Work Order ID 87160

Item Name: Crosstube Turning Detail

DART AEROSPACE LTD	Work Order:	87160
Description: Crosstube Assembly (412 High Aft)	Part Number:	D412-664-243
Inspection Dwg: D412-664-243 Rev: E		Page 1 of 2

DRAWING NO. D412-664-243	TITLE CROSSTUBE ASSEMBLY (412 HI AFT)	REV. E	DART AEROSPACE LTD ENGINEERING ORDER		D.E.O. NO. D412-664-243-E-1	SHEET NO. SHEET 1 OF 2	SCALE NTS
DRAWN	CHECKED	MFG. APPR.	APPROVED	DE APPR.			
DATE 11.03.31	DATE 11/03.31	DATE 11.03.31	DATE 11/03.31	DATE 11.03.31

**D412-664-243
ASSEMBLY DETAIL**

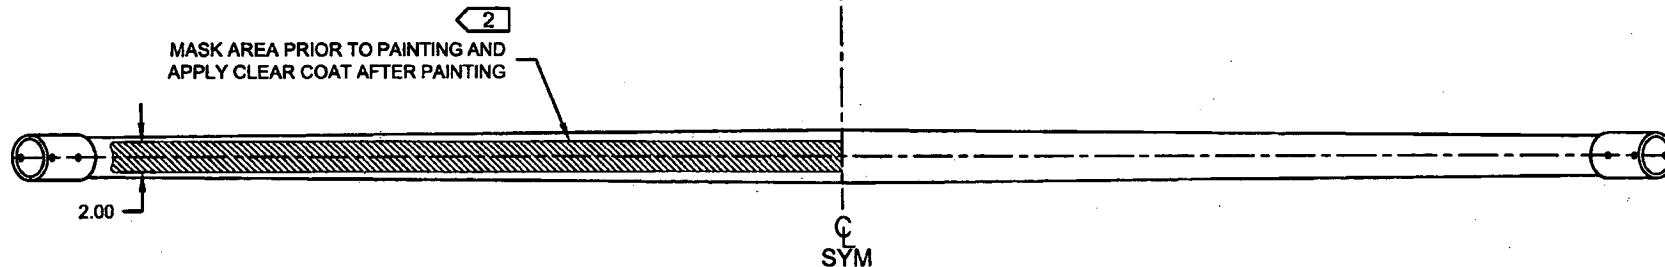
PURPOSE:

REMOVED ABRASION STRIP IN FAVOR OF A THIN LAYER OF PROSEAL 890.

IS:

D3189-1 CHAFING SHIELD (1, INSTALLED OVER PROSEAL 890)
MS21920-28 CLAMP, 2X
2 PL

WAS:

D2856-600-1009 ABRASION STRIP
D3189-1 CHAFING SHIELD (1, INSTALLED OVER ABRASION STRIP)
MS21920-28 CLAMP, 2X
2 PL
